City of Portland, Oregon
Bureau of Development Services
Land Use Services

**NOTICE OF A TYPE II DECISION ON A PROPOSAL IN
YOUR NEIGHBORHOOD**

**CASE FILE NUMBER: LU 09-105209 DZ - DESIGN REVIEW FOR
STOREFRONT REMODEL AND ROOFTOP MECHANICAL**

Site Address: 1705 NW 14TH AVENUE

09.105209 02
 EX. C-3

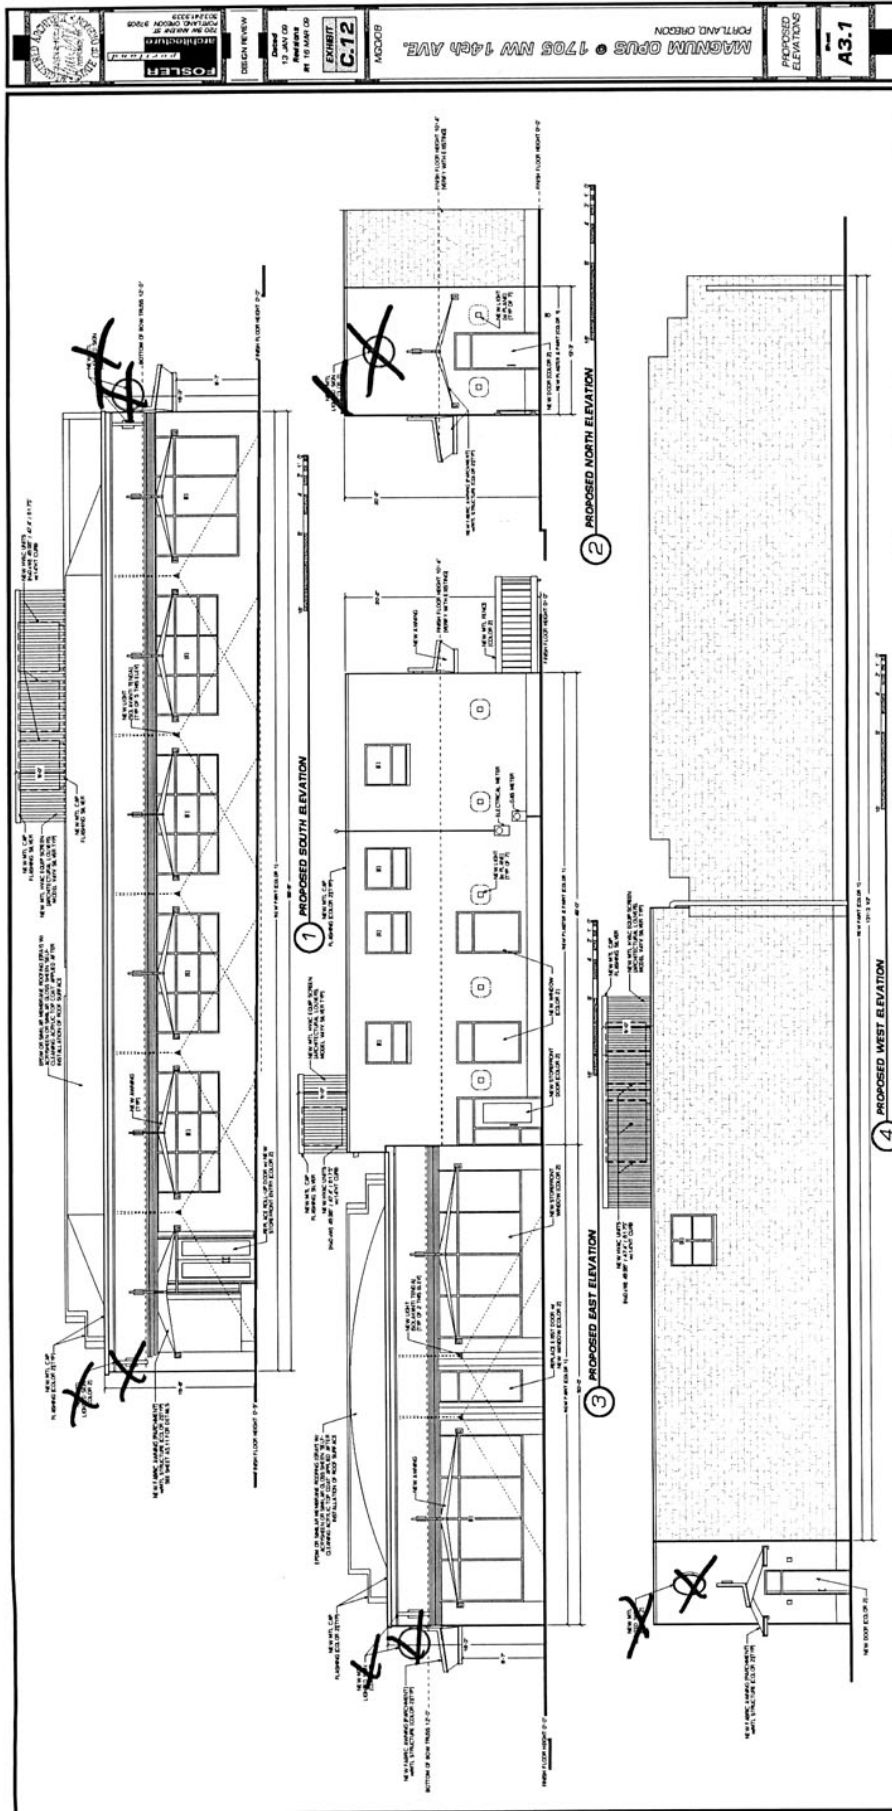
- No objection to approval. Non-standard items in the right-of-way in NW 14th Avenue and NW Savier Street are not approved (i.e. circular planters and metal fence).

Findings: At the northern corner of the site exists a small triangular outdoor area, the only part of the property that is undeveloped. This area is to contain 2 bike racks and new entrance to the office/storage area. A 4’-6” metal fence is proposed along a portion

of the east property line to help distinguish this area as part of the private development and provide a physical barrier between the bike racks and entrance and the public sidewalk. The open work design of the metal fence along with its modest height does not visually obstruct this area and allow for social interaction to occur. *This guideline is therefore met.*

Approval of storefront remodel, including awnings and light fixtures, and rooftop mechanical units and screen, per the approved site plans, Exhibits C-1 through C-21, signed and dated 3/19/09, subject to the following conditions:

- A. As part of the building permit application submittal, each of the 4 required site plans and any additional drawings must reflect the information and design approved by this land use review as indicated in Exhibits C.1-C.21. The sheets on which this information appears must be labeled, "Proposal and design as approved in Case File # LU 09-105209 DZ. No field changes allowed."
